Southern A&E, LLC
 7951 Troon Circle
 Austell, Georgia 30168
 (770)-819-7777

Project Name: **New Addition To:
 Harper Elementary School**
 Project Number: **01-606-031**
 Client **Clayton County Schools**
 City/State **Jonesboro, Georgia**

Addendum Date: July 29, 2009
Pre-Bid Mtg Date: July 22, 2009
Bid Date: August 11, 2009

END OF ADDENDUM NO. 1
01-606-031

TITLE: REVISED PARTIAL STAKING PLAN

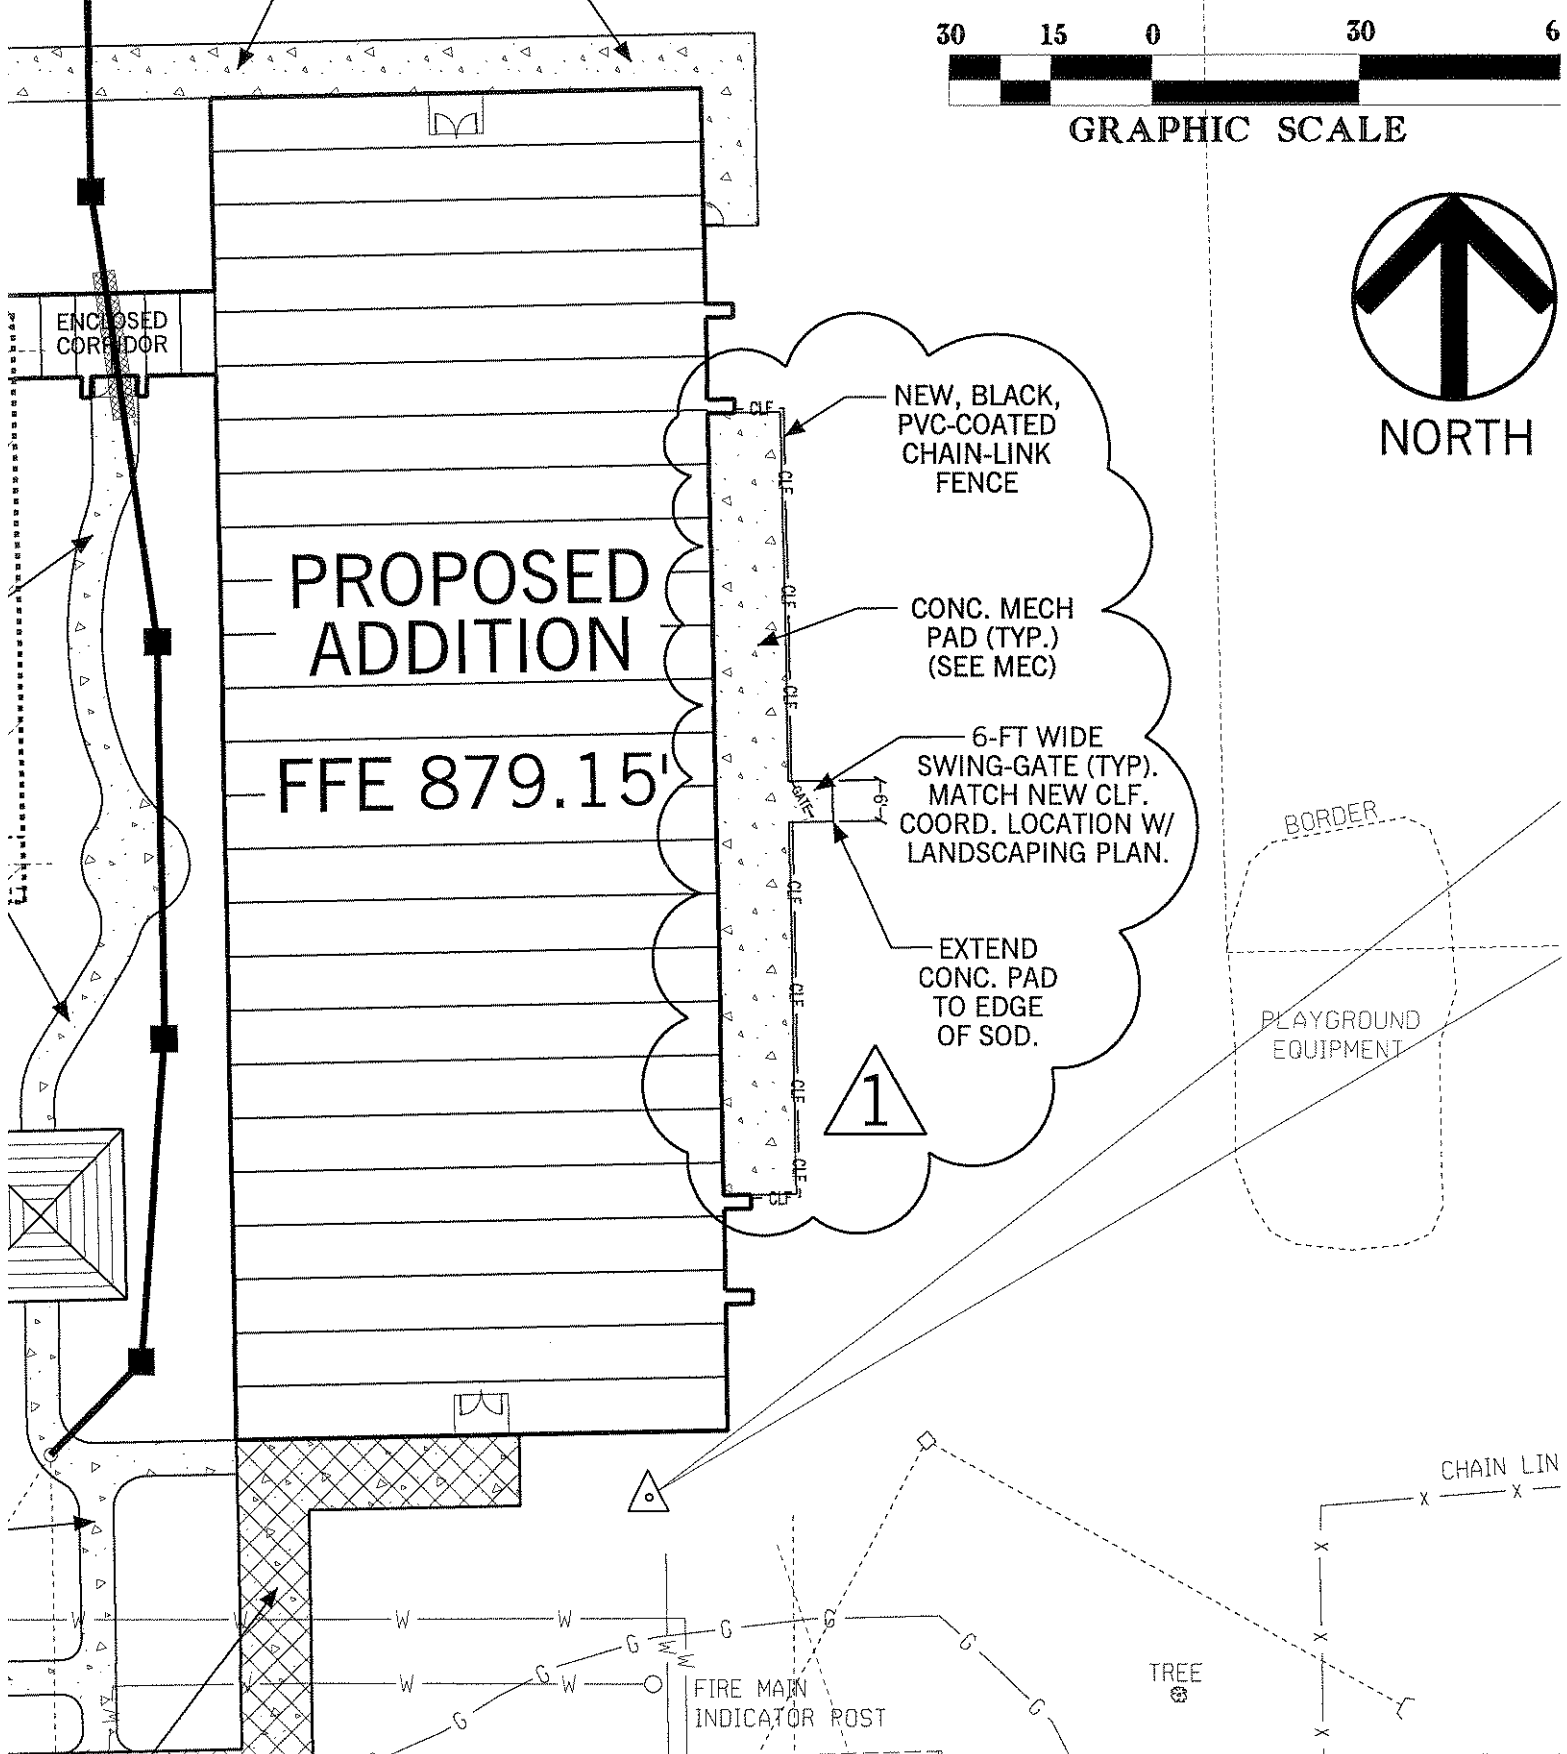
- REAR YARD => 20 FT. "
2. Drawing C6.0, 'STAKING PLAN'
 - a. **Add** a 6-foot-wide swing-gate to chain-link fence around mechanical pad. See attached Supplemental Drawing C6.0.S1.AD1.

- b. Extend concrete mech. pad to edge of sod, as shown on attached Supplemental Drawing C6.0.S1.AD1.
 - c. **Revise** Job Sign Detail as shown on attached Supplemental Drawing C6.0.S2.AD1.

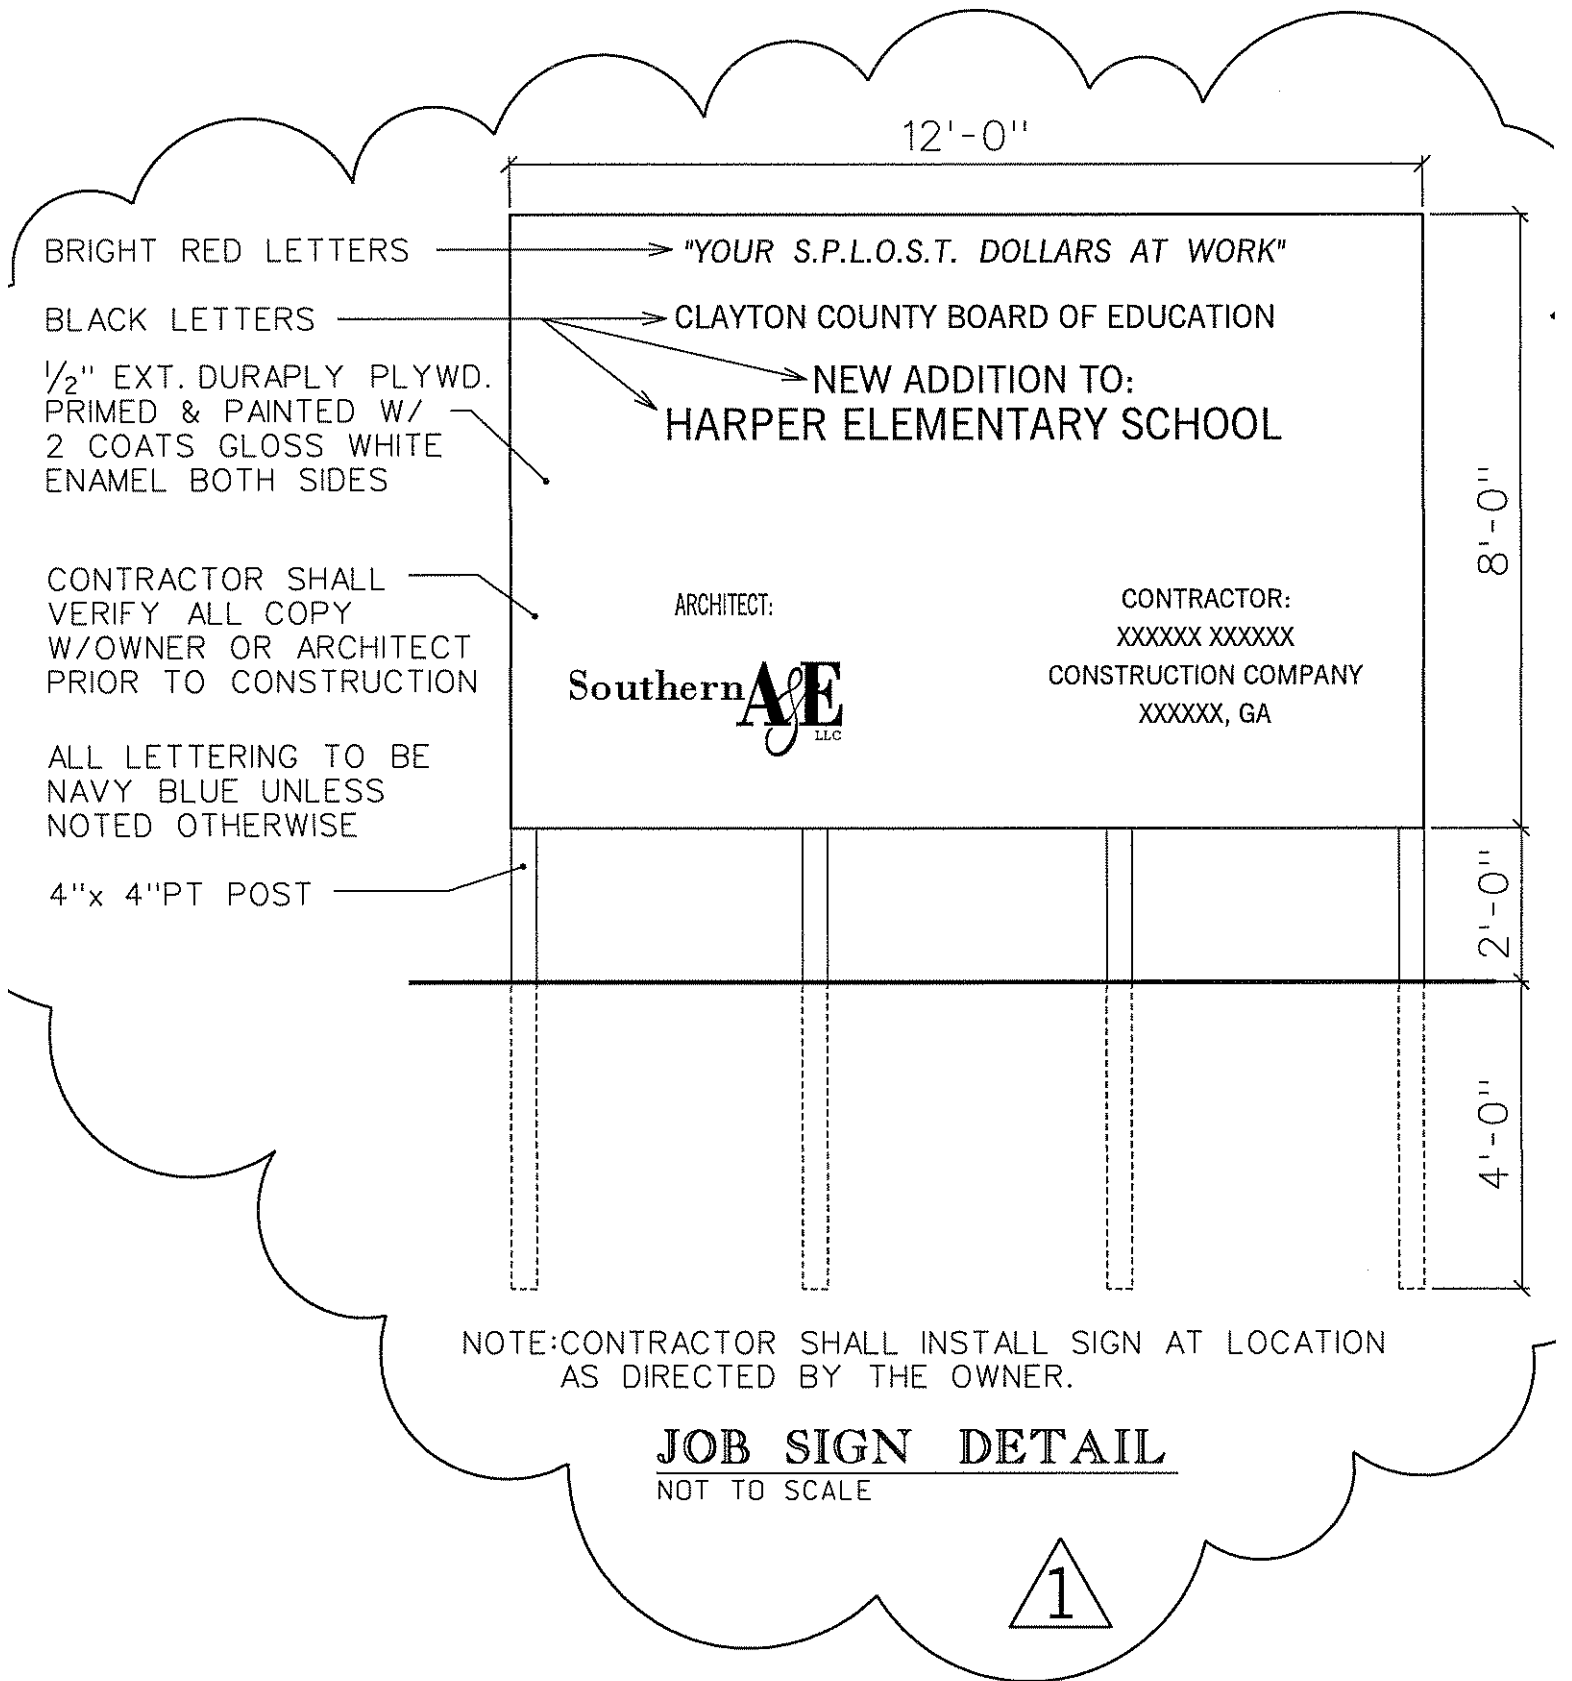
12. Drawing A10, Schedules, Details
 - a. **Change** Detail K20/A10, Job Sign Text to Read; Harper Elementary School, Riverdale, Georgia
13. Drawing A12, Enlarged Floor Plan
 - a. Add Mounting Height Schedule as shown on Supplemental Drawing A12.S1.AD1, copy attached.
14. Drawing S5
 - a. Revise Connector (Exit Lintel) as shown on Supplemental Drawings S5.S1.AD1 and S5.S2.AD1, copy attached.

TITLE: RECESSED EXIT @ ENCLOSED PASSAGE

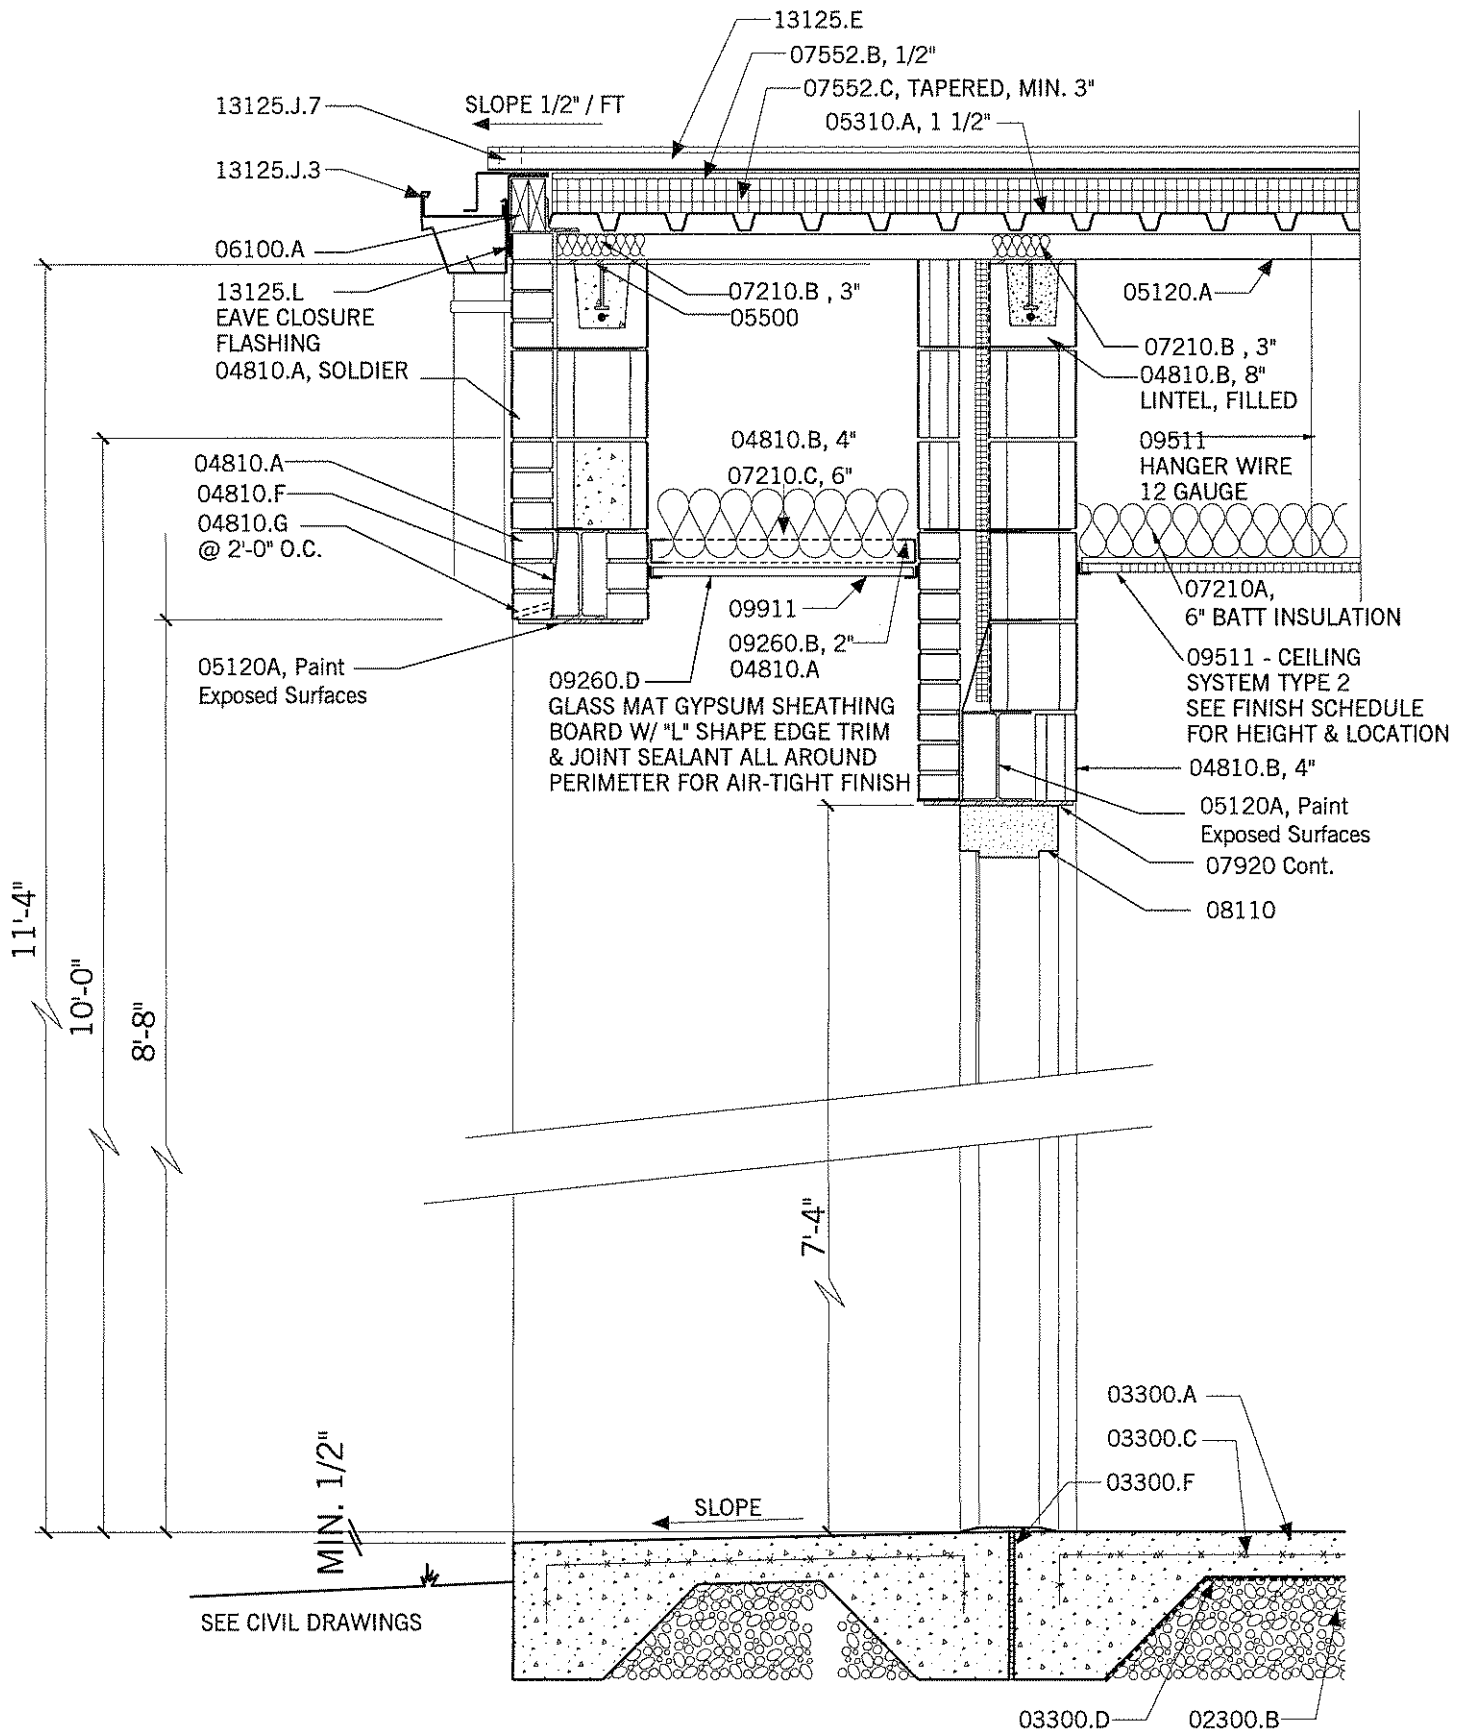
9. Drawing A08, Wall Sections
 - a. **Add** Section to Drawing A08, as shown on Supplemental Drawing A08.S1.AD1 'Recessed Exit @ Enclosed Passage', copy attached

10. Drawing A02, New Addition Floor Plan
 - a. **Add** Section Cut Symbol M12/A08 at Exit Located at Door Number 322a.
11. Drawing A03, New Addition Reflected Ceiling Floor Plan

S5.S1.AD1
 DRAWING 2 OF 2

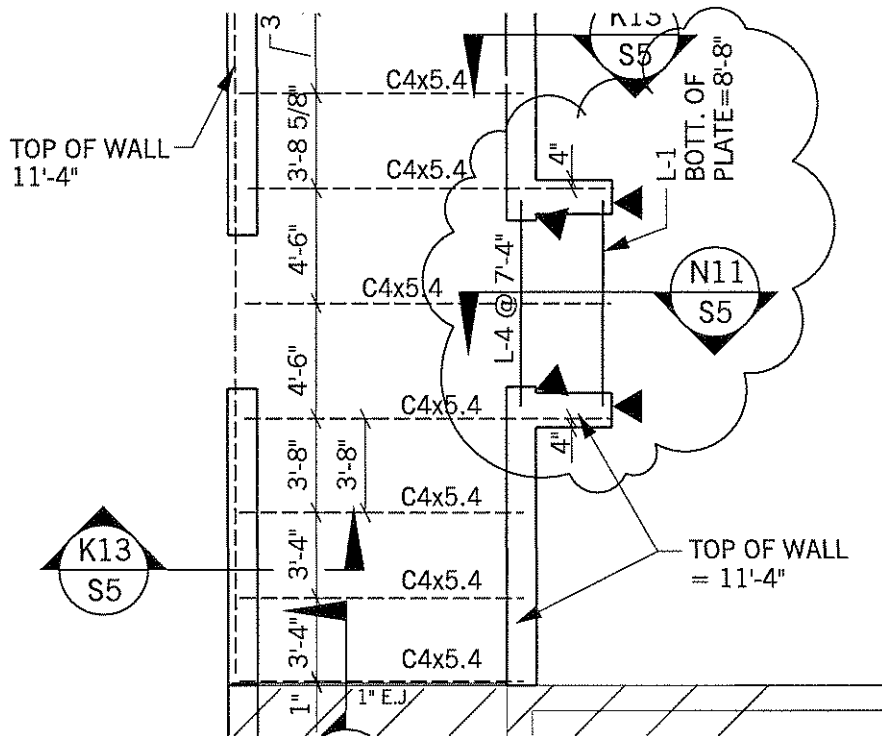
CHANGE LINTEL ELEV.

TITLE: REVISED PARTIAL PLAN - CLASSROOM WING ADDITION

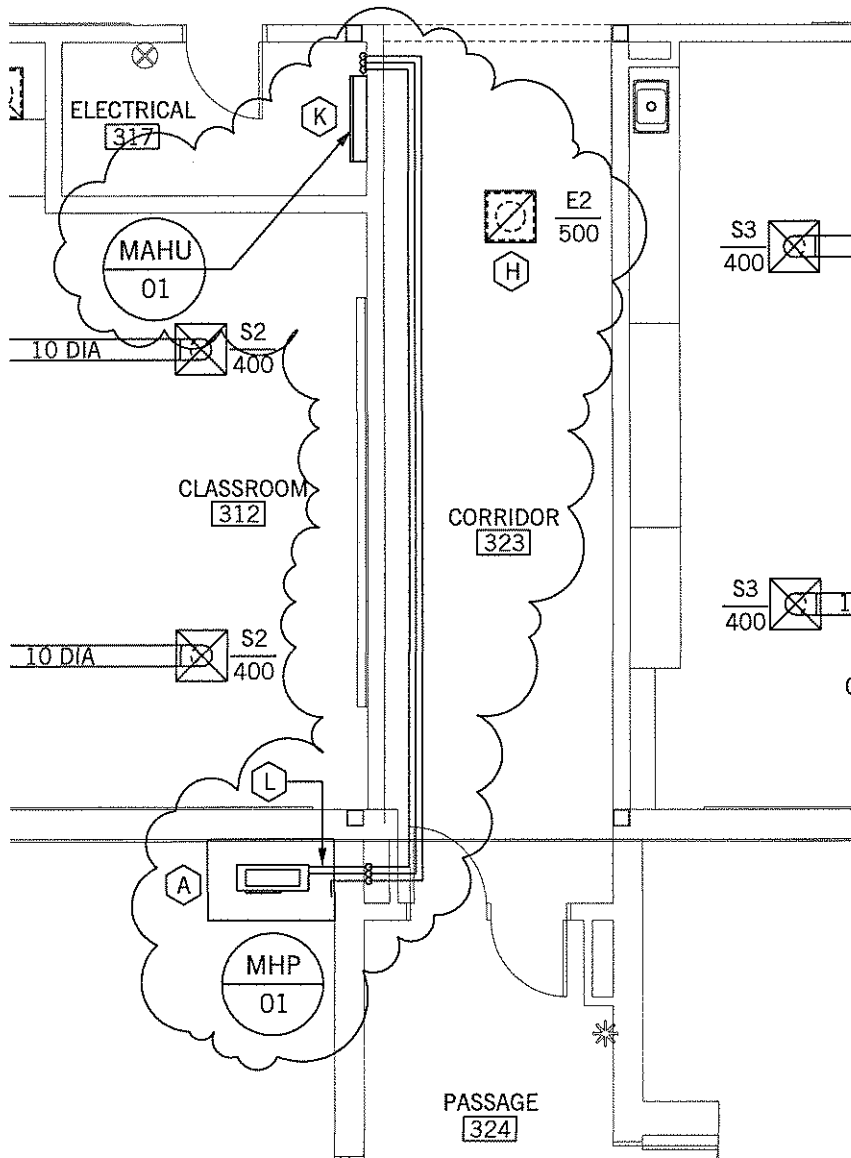
3. Drawing M2
 - a. Add mini-split system air conditioning system MAHU/MHP-01, delete door grille in Electrical 317, and add exhaust grille in corridor as shown on supplemental drawing M2.S1.AD1.
